SUBJECT: PALISADES PLANT - ISSUANCE OF AMENDMENT RE: PRESSURE-TEMPERATURE
LIMITS (TAC NO. M90650)

AMENDMENT NO. 163 TO FACILITY OPERATING LICENSE NO. DPR-20-PALISADES

ATTACHMENT TO LICENSE AMENDMENT NO. 163

Figure 3-1 Pressure-Temperature Limits for Heatup

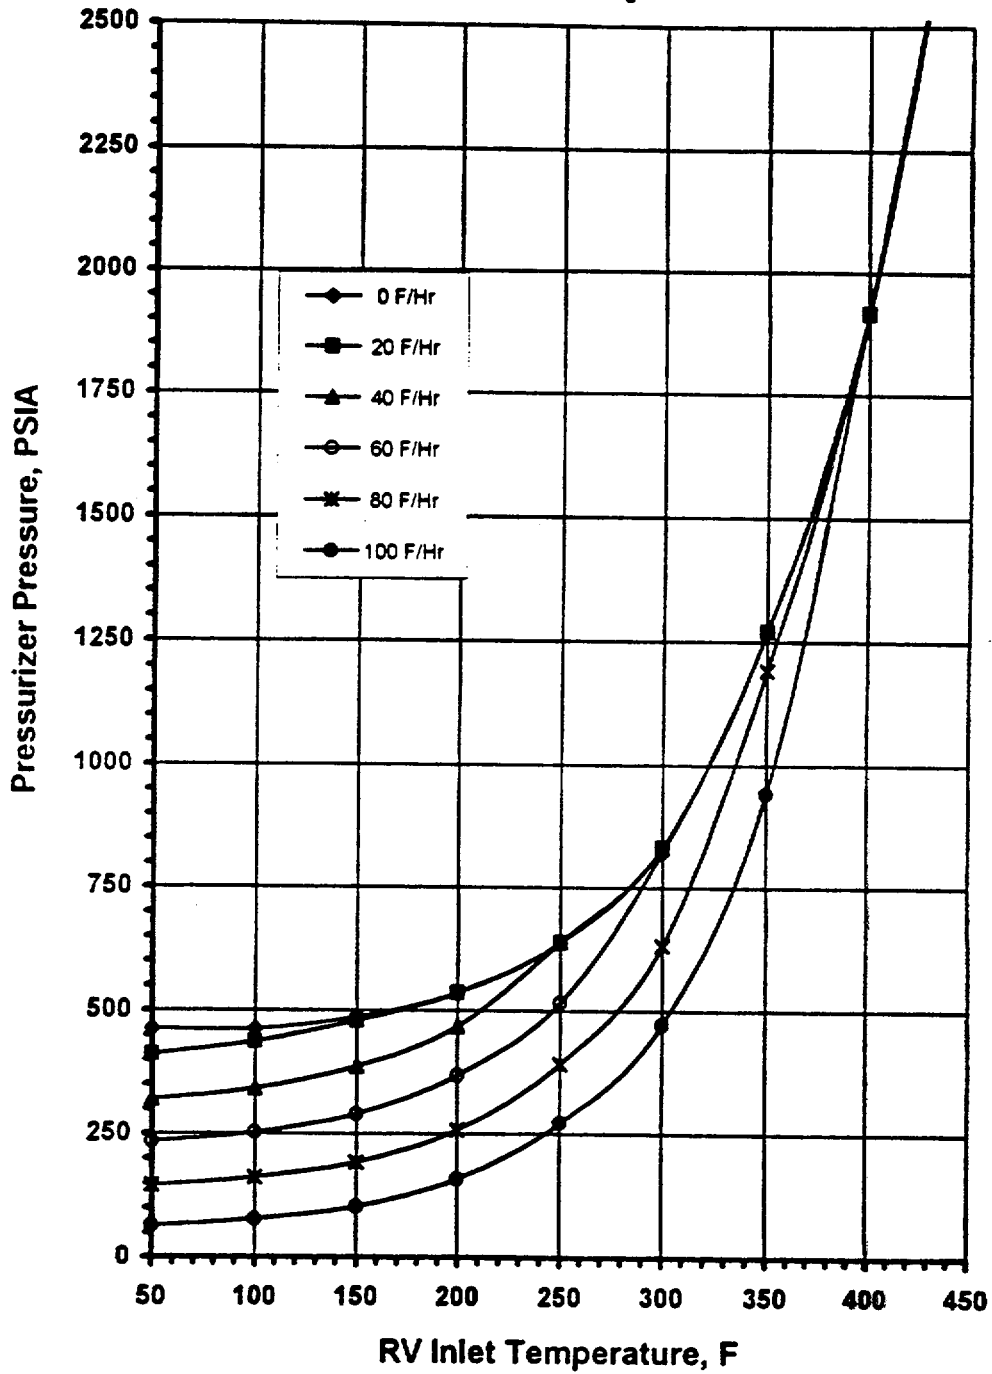
The PCS P-T limits during plant heatup and cooldown for Palisades Plant are specified in TS Figures 3-1 and 3-2. The existing PCS P-T limits were calculated for a reactor vessel wall fluence of 1.8×10^{19} nvt. The pressurizer PORVs are used for overpressure mitigation against an inadvertent mass addition or energy addition event during low-temperature operating conditions. The PORV setpoints are specified in TS Figure 3-4 which assures that the transient peak PCS pressure are within the P-T limits specified in Figures 3-1 and 3-2. Restrictions for starting the first PCP are specified in TS 3.1.1h. These restrictions would ensure that the PCS P-T limits are protected against an energy addition event while the secondary side temperature is more than 100°F hotter than the PCS temperature. TS 3.1.1h also ensures the closure of shutdown cooling system isolation valves prior to forced circulation to protect the shutdown cooling system from exceeding its pressure limit. Limitations for HPSI pump operability during low temperature operation conditions are specified in TS 3.3 which would eliminate the potential mass addition from the HPSI pumps during an inadvertent safety injection actuation.

CPCo proposed changes to the P-T curves in TS Figures 3-1 (for heatup) and 3-2 (for cooldown), to TS Figure 3-4 (for PORV setpoints), to TS 3.1.1h (for starting first PCP), and to TS 3.3 (for HPSI pump operability). The licensee states that the existing PCS P-T limits were based on a reactor vessel wall fluence of 1.8×10^{19} nvt. The changes in TS 3.1.1h and TS Figure 3-4 are intended to protect against P-T limits specified in the revised TS Figures 3-1 and 3-2. The revised TS 3.3 would allow the HPSI pumps to remain operable during low temperature operating conditions so that these pumps could be manually actuated for PCS makeup in case the shutdown cooling capability is lost. However, when the PCS temperature is less than 300°F, the HPSI pumps would be rendered incapable of injection into the PCS by manually interrupting the power supplies to HPSI pumps or by isolating the flow path.

Substituting the limiting ARTs into equations in SRP 5.3.2, the staff verified that the proposed P-T limits satisfy the requirements in paragraphs IV.A.2 and IV.A.3 of Appendix G of 10 CFR Part 50.

The staff has performed an independent analysis to verify the licensee's proposed P-T limits, and reviewed the chemical composition data from PTS discussions during the November 21, 1994, meeting. The staff concludes that the proposed P-T limits for heatup and cooldown are valid for a neutron fluence at the limiting weld of $2.192E19$ n/cm², which corresponds to 6 EFPY from the beginning of cycle 10 because (1) the limits conform to the requirements of Appendix G of 10 CFR Part 50 and GL 88-11, and (2) the material properties and chemistry used in calculating the P-T limits are consistent with data submitted as part of the licensee's PTS evaluation and the staff's PTS assessment. Hence, the proposed P-T limits may be incorporated into the Palisades TSSs.

Figure 3-4 LTOP Setpoint LIMIT

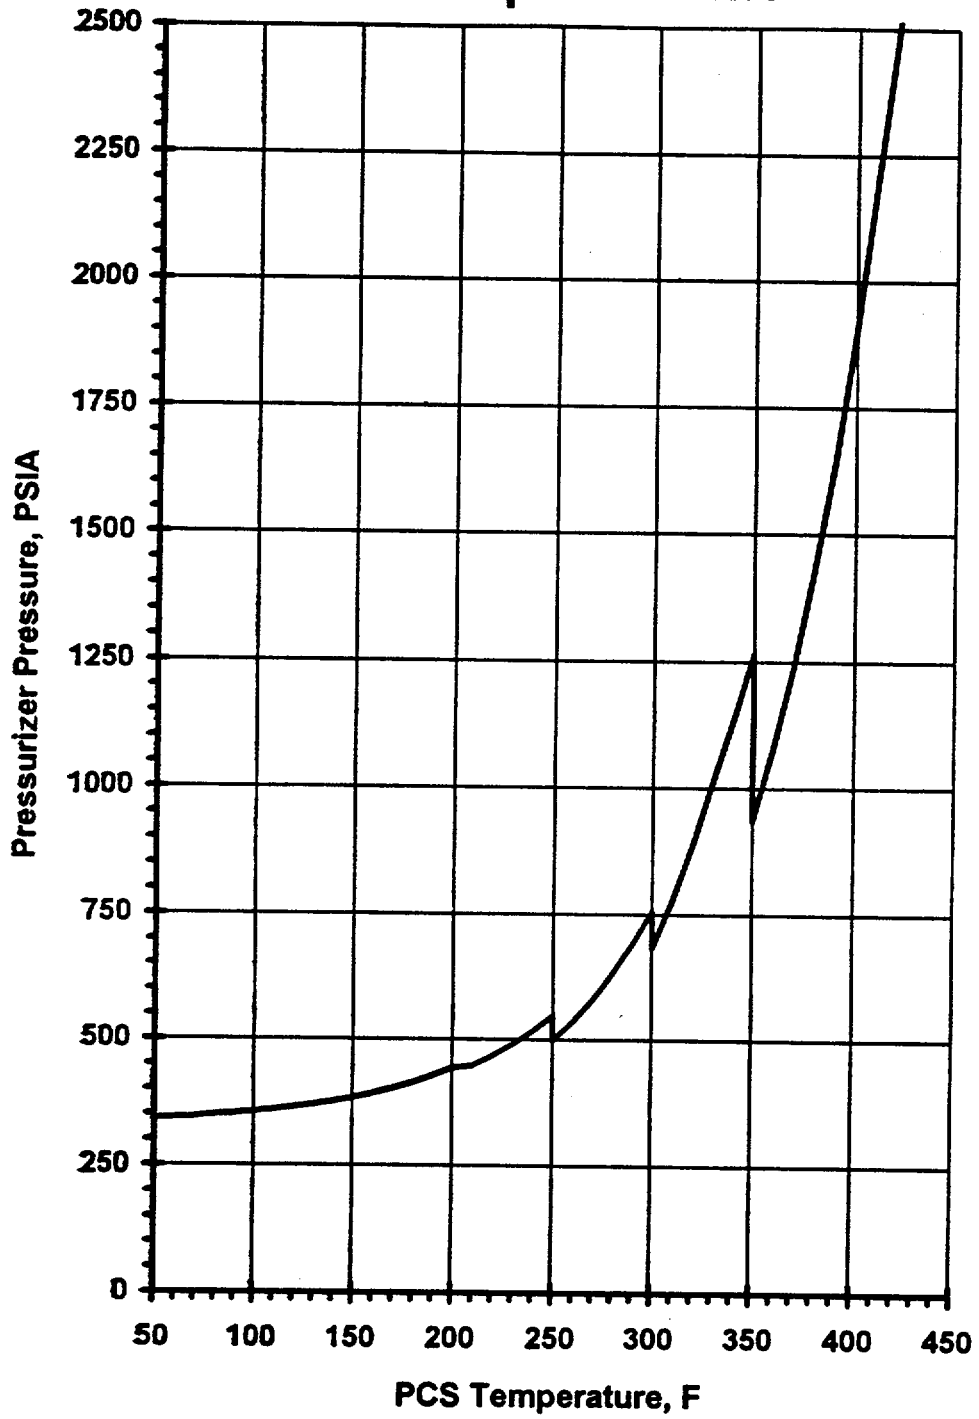
In the current TS, when the temperature of the PCS cold leg is less than or equal to 430°F with the reactor vessel head unremoved, low temperature overpressurization is protected by either of the pressurizer PORVs with lift settings specified in TS Figure 3-4. These settings were developed to avoid PCS pressure from exceeding the PCS P-T limits which were developed per the requirements of 10 CFR Part 50, Appendix G. The new PORV settings were determined using the proposed PCS P-T limits and the ASME Code Case N-514 which allows the maximum allowable P-T limits to be 10% above the P-T limits specified in the revised TS Figures 3-1 and 3-2. Since the ASME Code Case N-514 has not been officially endorsed by NRC, the licensee submitted an exemption request on February 10, 1995. On March 2, 1995, the staff approved an exemption from the requirements of 10 CFR Part 50, Appendix G, so that the Palisades Plant could take this needed 10% allowance in the maximum allowable P-T limits to avoid operational difficulties at Palisades.

The most limiting energy addition transient assumed in the licensee's analysis is the start of the first idle PCP with secondary system temperature less than 100°F above the PCS cold leg temperature. The results of the analysis indicates that the transient PCS peak pressures are below their allowable P-T limits under isothermal conditions. The PCS was assumed in water solid condition prior to the transient for added conservatism in the licensee's analysis to support the proposed PORV settings.

The limit in Figure 3-4 includes an allowance for pressure overshoot during the interval between the time pressurizer pressure reaches the limit, and the time a PORV opens enough to terminate the pressure rise.
